**25 Talbot Lane Warehouse & Distribution Center
Summary of Site Plan Changes
Planning & Zoning Commission Site Plan Application**

Re: 22-01p Additional detail and information for the South Windsor Planning and Zoning Commission for public input.

APPLICATION 22-01P, 25 TALBOT LANE SITE PLAN

Exhibit A

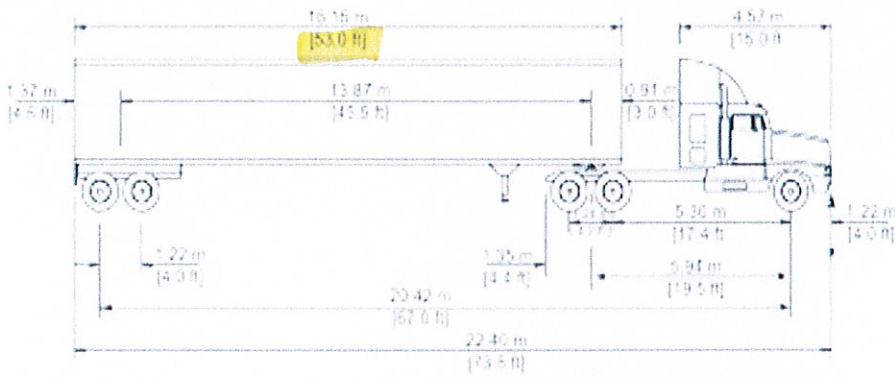
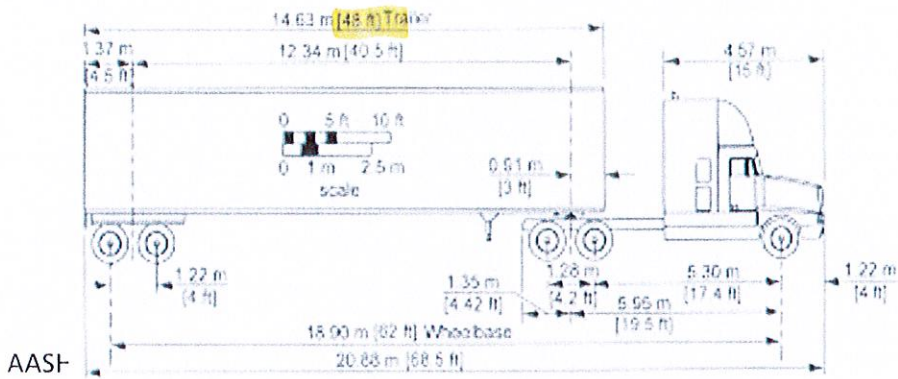
2/15 When reviewing the applicant’s plans the parking space at the dock is 60’ with a 70’ aisle and the parking lot across from the dock is 60’. Tractor trailer wb67 units are 73-75 ft. in length. This means a truck backed in at dock has up to a 15 ft. overhang into the main aisle. The truck parked in the adjacent 60’ truck parking space is also 75 ft. with a 15ft. overhang into the main aisle. The overhangs on both sides reduce the main aisle down from 70’ to 40’. Using the Brazhuman truck turn radius provided in Exhibits B, E, we find that a tractor trailer pulling out next to another unit needs more than 40’ to navigate the turn to get out of the dock. The main aisle is not large enough for orderly traffic flow with high volume and will lead to on site conflicts that will back up into the queuing area and the main entrance with overflow being in

This is highlighted in the Brazhuman analysis design vehicles and turning radii, (pages 8,18), provided in Exhibits B,F. With this proposed high volume site, trucks will be exiting and entering simultaneously. This means trucks will be operating into the opposing lane of traffic for 40 feet making turns in and off of Governors, from Talbot and in and out of the site. Please see the swept path, off tracking turning exhibit with site plan overlays Exhibits C,D,F, using AASHTO design of the intersections.

Exhibit C Swept Path & off tracking by Brazhuman Corp.

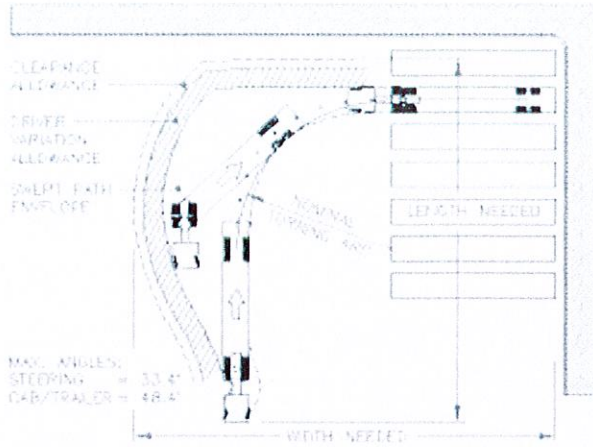
A wb67 tractor trailers attempting to negotiate turns on a site designed for WB-62's are depicted on the attachments to the Butler report. The report indicates the "swept-path width" involved in a wb67 tractor trailer making a turn. By superimposing the "swept-path width" onto the Applicant's Site Plan the conflicts become obvious.

Excerpt from 22-01P
Site Plan Revision
posted March 3,
2022 Sheet C-GD1

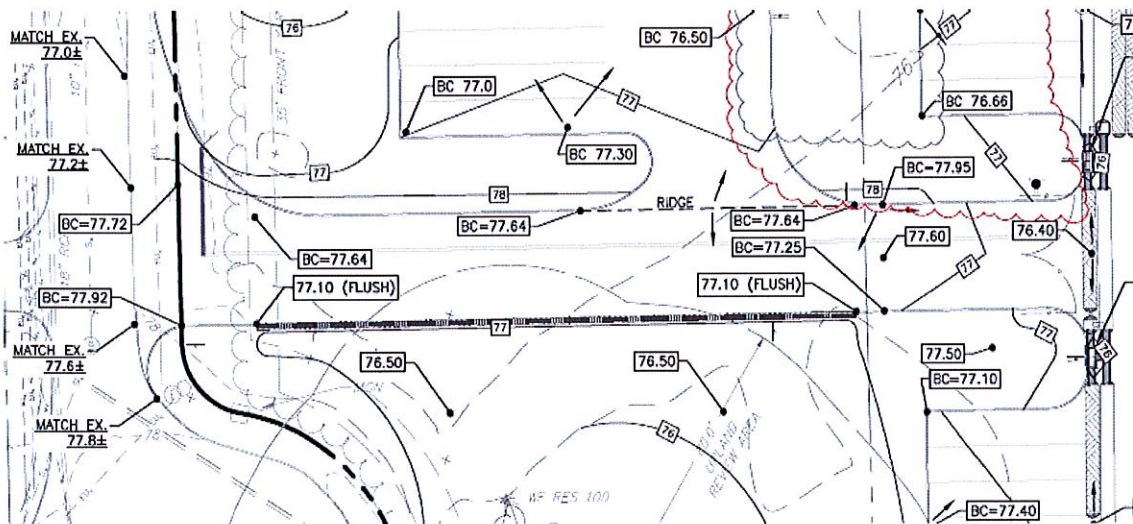
No Catch Basins Appear Anywhere Near Truck Entrance

- Stormwater Management Report states stormwater will depart adjacent basin through 36" pipe on Carla's Pasta site
- Refer to Improvement Location Survey Record for Carla's Pasta Sheet V-2 page 2 of 3

Exhibit B

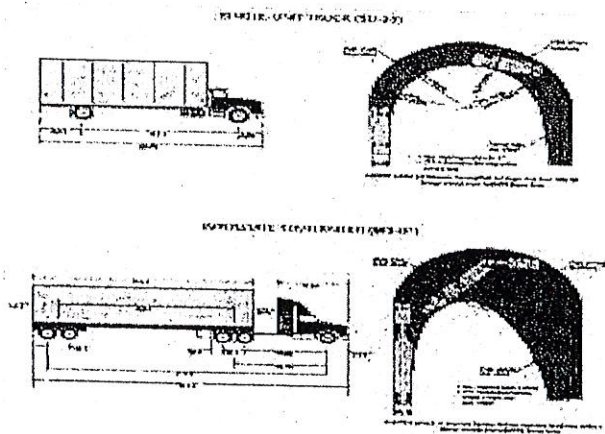
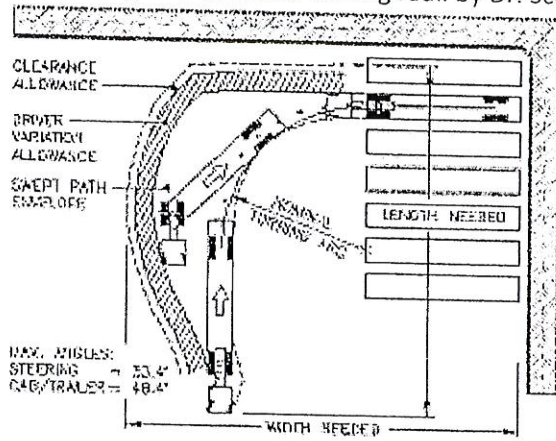
This is highlighted in the Brazhuman analysis design vehicles and turning radii (pages 8,18), provided in Exhibits B,F. With this proposed high volume site, trucks will be exiting and entering simultaneously. This means trucks will be operating into the opposing lane of traffic for 40 feet making turns in and off of Governors, from Talbot and in and out of the site. Please see the swept path, off tracking turning exhibit with site plan over lays Exhibits C,D,F, using AASHTO design of the intersections.

EX F 3

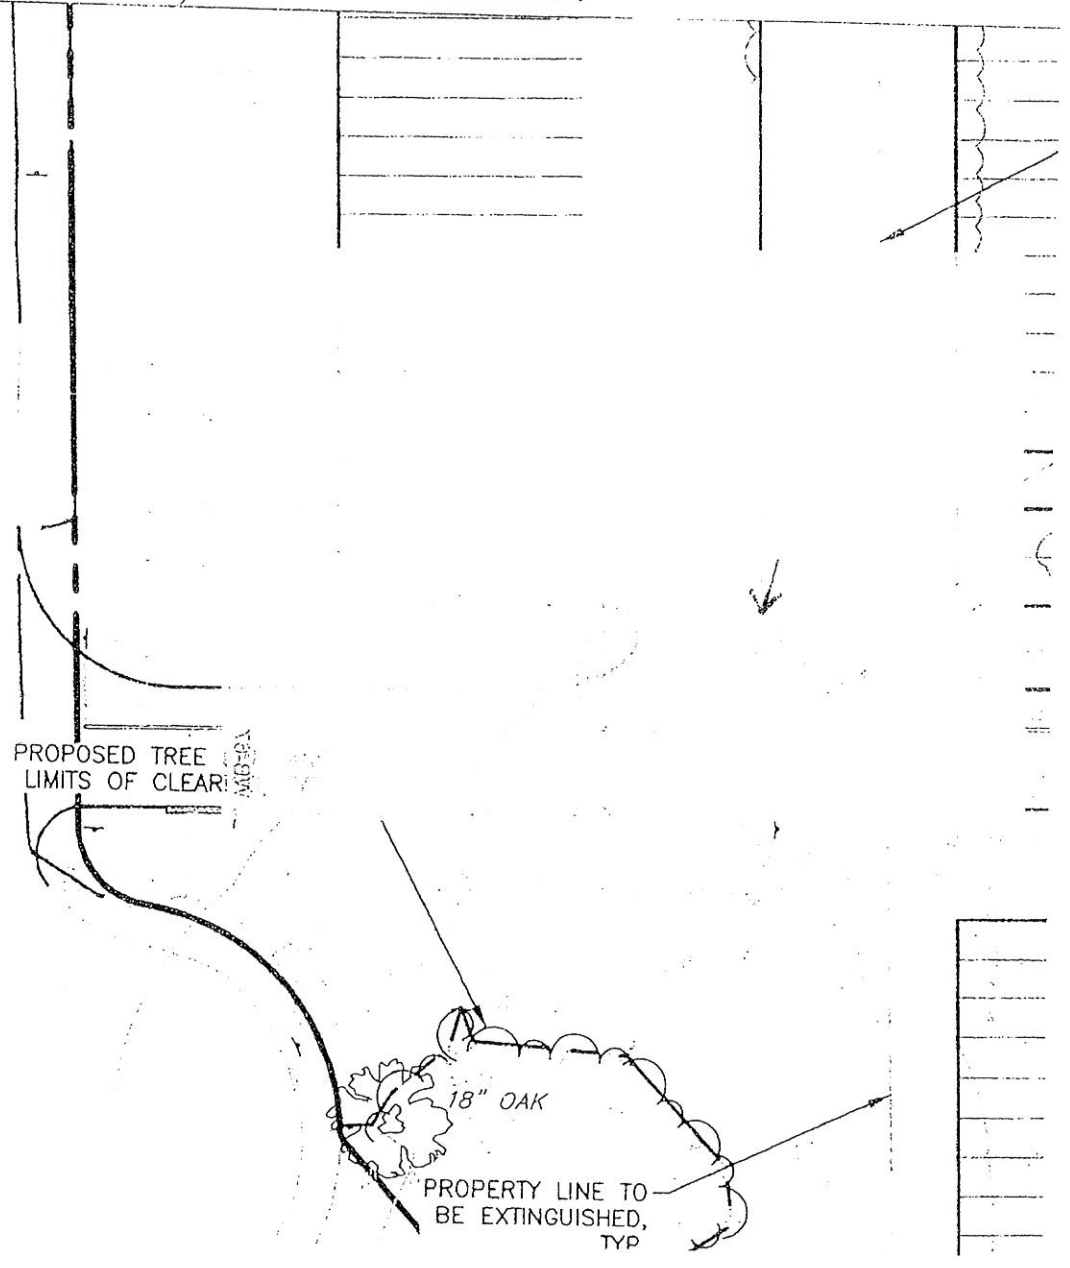
Re: Truck radius overlay

EX 14

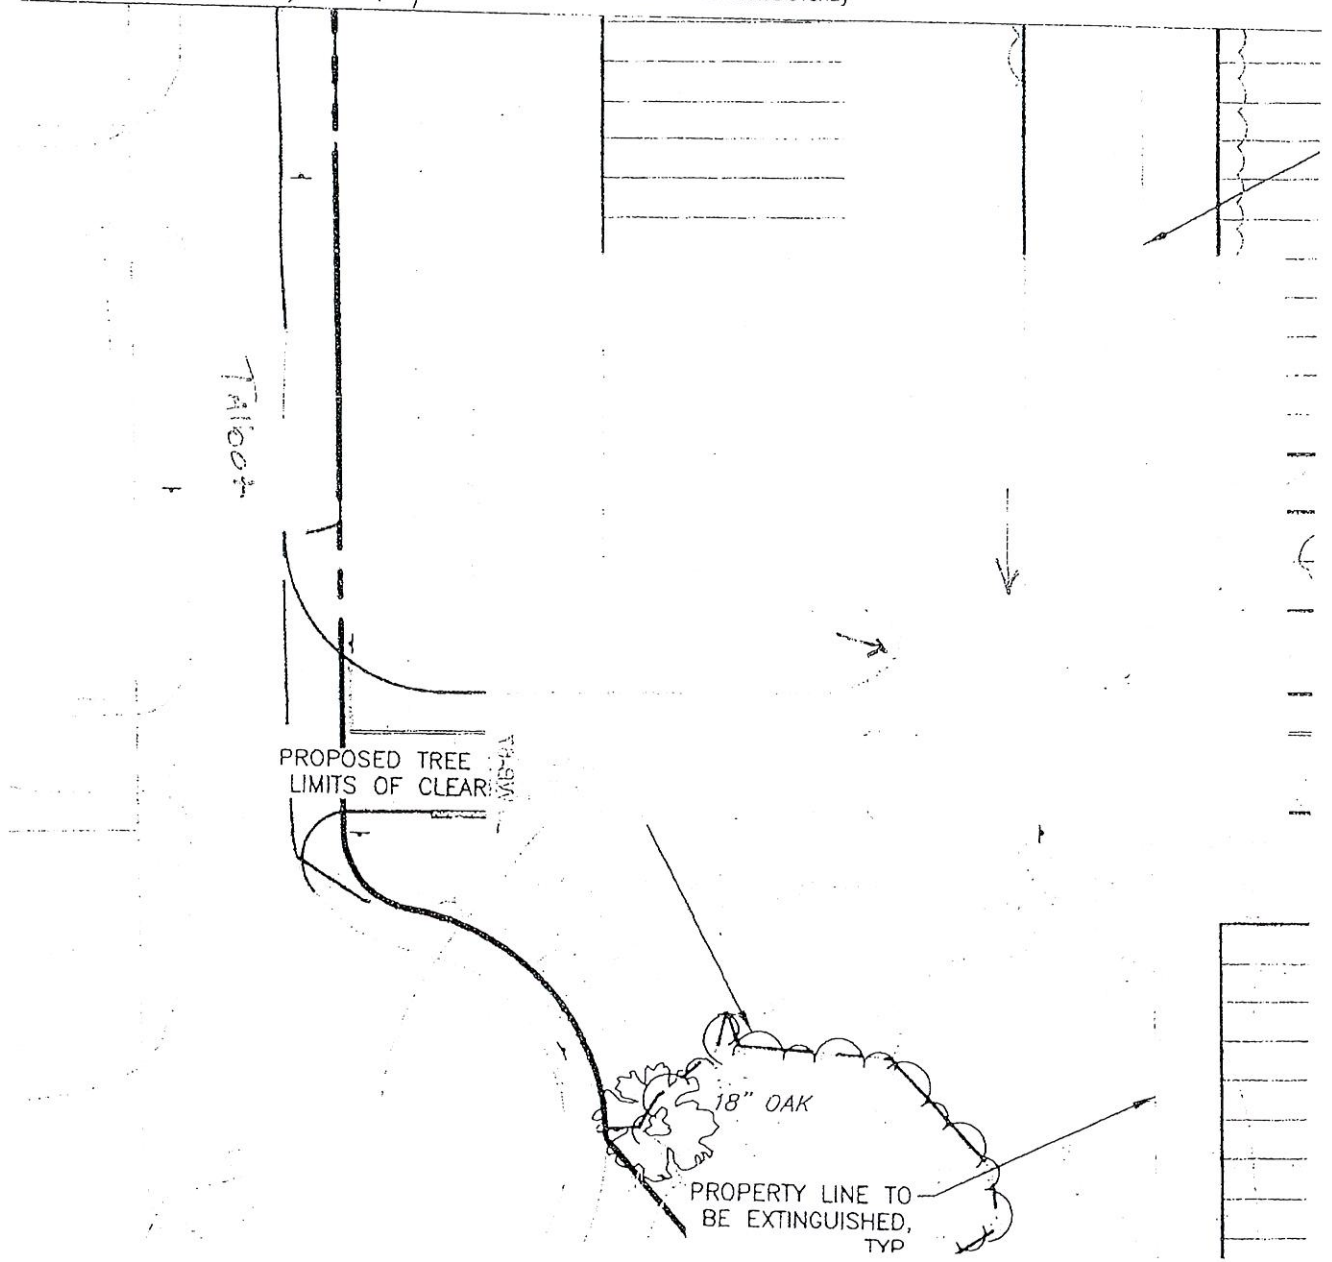
Re: Truck radius overlay
